Hope Creek Generating Station
Renewed Facility Operating License No. NPF-57
NRC Docket No. 50-354

Subject: Hope Creek Generating Station Compliance with NRC Order to Modify Licenses with Regard to Reliable Spent Fuel Pool Instrumentation (Order EA-12-051) and Responses to Requests for Additional Information

**Hope Creek Generating Station (HCGS)
Response to Interim Staff Evaluation and Request for Additional Information
Reliable Spent Fuel Pool Instrumentation**

Figure 1a

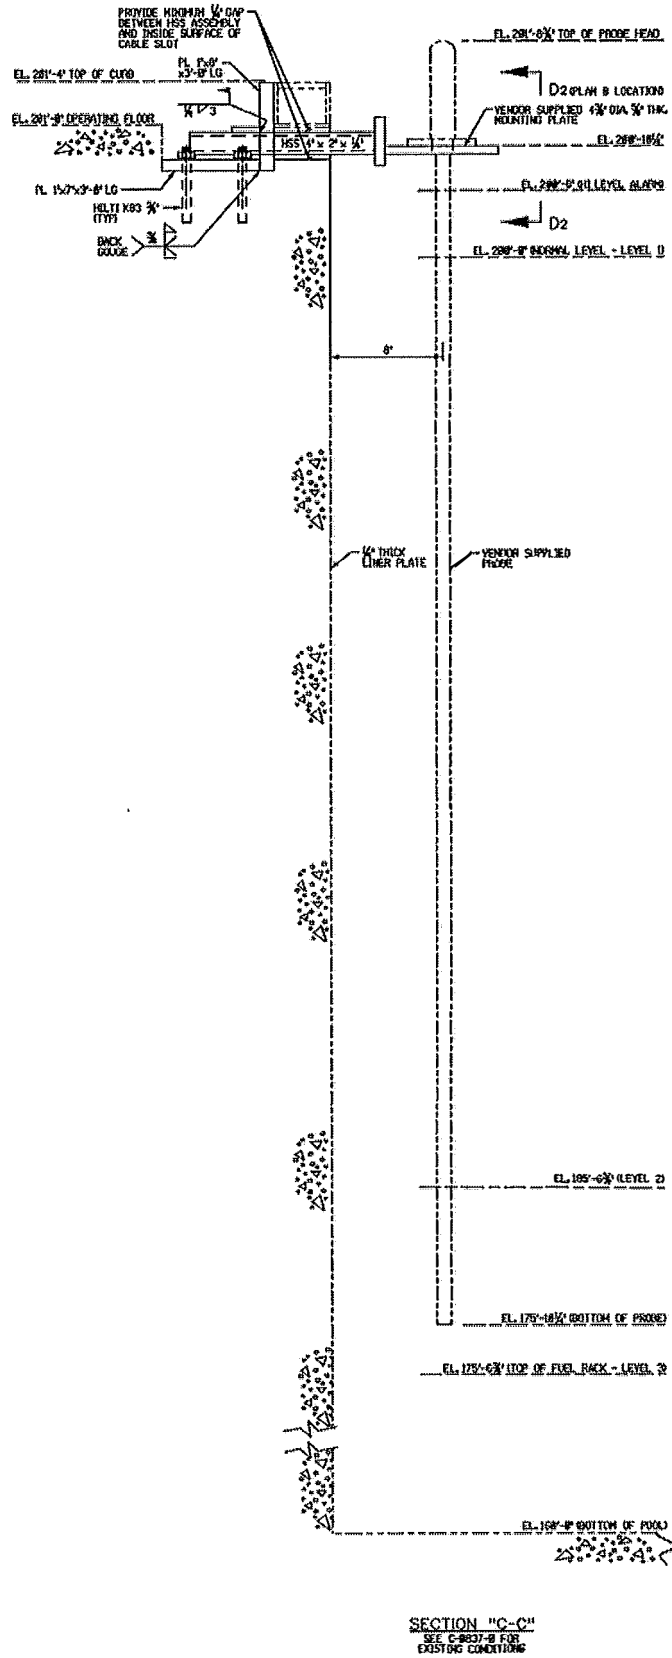
- a) The design criteria that will be used to estimate the total loading on the mounting device(s), including static weight loads and dynamic loads. Describe the methodology that will be used to estimate the total loading, inclusive of design basis maximum seismic loads and the hydrodynamic loads that could result from pool sloshing or other effects that could accompany such seismic forces.
- b) Indicate in a schematic, the portions of the level sensor that will serve as points of attachment for mechanical/mounting or electrical connections.
- c) A description of the manner by which the mechanical connections will attach the level instrument to permanent SFP structures so as to support the level sensor assembly.

- b) The support structures are anchored to the concrete curb around the SFP above the refueling deck as shown in the following figures:

- c) The level sensor is designed to be attached near its upper end to the support structure as shown in Figures 1a, 1b, 2, 3, and 4.
